# UNITED STATES PATENT AND TRADEMARK OFFICE

APPLICATION NO.	FILING DATE	FIRST NAMED INVENTOR	ATTORNEY DOCKET NO.	CONFIRMATION NO.
09/989,271	11/20/2001	Michael C. Smyk	FCI-2632/C3069	9590

# Office Action Summary

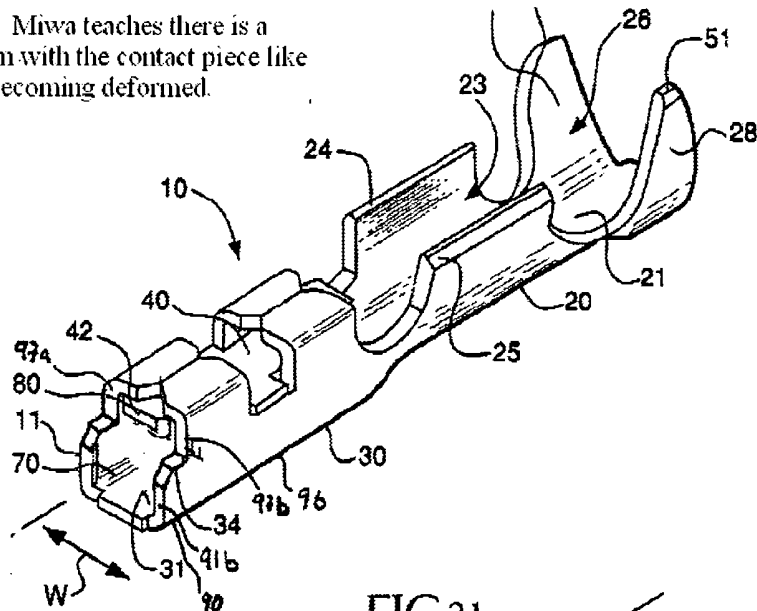
-- In reference to claims 20-42, FCI's Jumbo PV Receptacle shows substantially the invention as claimed. However, FCI's Jumbo PV Receptacle does not show a protecting wall portion.

Miwa shows a protecting wall portion 51.

It would have been obvious to one of ordinary skill in the art at the time the invention was made to protect the bent portion of FCI's Jumbo PV Receptacle with the protecting wall portion of Miwa (see examiner's figures) because, as taught by Miwa, the resilient contact piece needs protected before it is placed into the housing (column 1, lines 40-50).

Step 1: Miwa teaches there is a problem with the contact piece like FCT's becoming deformed.

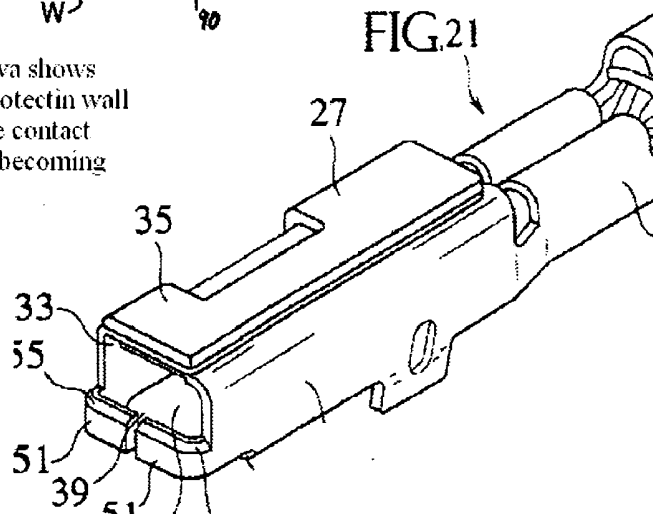
-- In response to applicant's argument (page 6, lines 5-6 ) concerning that FCI's jumbo PV Receptacle does not show claim 30's limitations and that Miwa does not show claim 30's limitations, the argument is not convincing. 37 CFR § 1.111(b) states, "A general allegation that the claims define a patentable invention without specifically pointing out how the language of the claims patentably distinguishes them from the references does not comply with the requirements of this section." Applicant has failed to specifically point out how the language of the claims patentably distinguishes them from the references because substantially every element number pertaining to claim 31 is shown in Step 1 and the associated examiner's figure.

Step 2: Miwa shows putting a protection wall prevents the contact piece from becoming deformed.

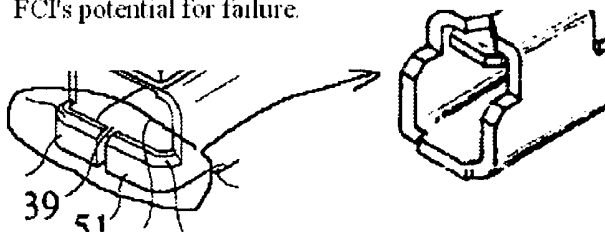
Although applicant did not claim the protection wall (substantially equivalent to Miwa protection wall 51 (see the examiner's figure associated with Step 2 of the rejection)) FCI's jumbo PV Receptacle as modified by Miwa also shows the same protection wall and resulting structure.
